Process Sheet

Customer : CU-DAR001 Dart Helicopters Services Drawing Name : 350 SKIDTUBE ASSEMBLY RH
Job Number : 41093
Estimate Number : 10265
P.O. Number :
This Issue : 11/08/2008 S.O. No. :
Prsht Rev. : NC Part Number : D350636012
First Issue : 11/08/2008 Type : SKIDTUBES Drawing Number : D2750 UNDER REVIEW
Previous Run : 41059 Drawing Revision :
Material :
Due Date : 30/08/2008 Qty: 1 Um: Each

DART SERVICE INSTRUCTION

A	NEW ISSUE	PH	08.05.14
REV.	DESCRIPTION	BY	DATE
DESIGN	PH	DART AEROSPACE USA, INC PORT HADLOCK, WA	
DRAWN	PH		
CHECKED		DRAWING NO.	REV. A
MFG. APPR.	N/A	DSI 9413	SHEET 1 OF 3
APPROVED		TITLE	SCALE
DE APPR.		WEARSHOE MODIFICATION	NTS
DATE	08.05.14	COPYRIGHT © 2008 BY DART AEROSPACE USA, INC THIS DOCUMENT IS PRIVATE AND CONFIDENTIAL AND IS SUPPLIED ON THE EXPRESS CONDITION THAT IT IS NOT TO BE USED FOR ANY PURPOSE OR COPIED OR COMMUNICATED TO ANY OTHER PERSON WITHOUT WRITTEN PERMISSION FROM DART AEROSPACE USA, INC.

FIGURE 1 - WEARPLATE MODIFICATION

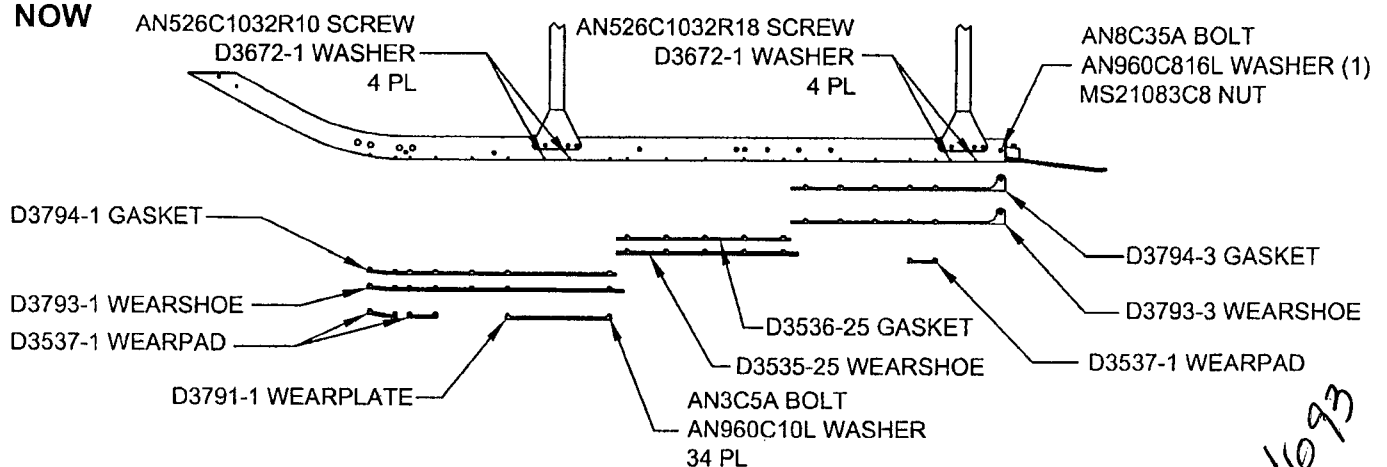
THE WEARPLATES ON D350-636-011/-012/-013/-014 SKIDTUBES AT CHG 004 (AND LATER) HAVE BEEN MODIFIED AS SHOWN IN FIGURE 1 BELOW TO ELIMINATE THE POSSIBILITY OF INTERFERENCE BETWEEN THE WEARPLATES AND CROSSTUBE SADDLES AT INSTALLATION. THERE IS NEGLIGIBLE WEIGHT CHANGE ASSOCIATED WITH THIS MODIFICATION.

(AN526C1032RXX SCREW LOCATIONS NO LONGER USED TO MOUNT WEARSHOES)

TO INSTALL THE DSI 9413-011 KIT, REMOVE THE EXISTING WEARSHOES/GASKETS UNDER THE FWD/AFT SADDLES AND INSTALL NEW WEARSHOES/GASKETS AS SHOWN IN FIGURE 1. PLUG UNUSED HOLES WITH AN526C1032RXX SCREWS AND D3672-1 WASHERS. INSTALL SCREWS WITH SIKAFLEX -241/-291 OR PROSEAL 890 OR MIL-S-8802 CLASS 'B2' SEALANT AS SHOWN IN FIGURE 1. **NOTE:** SOME OF THE PREVIOUSLY INSTALLED HARDWARE IS NO LONGER REQUIRED.
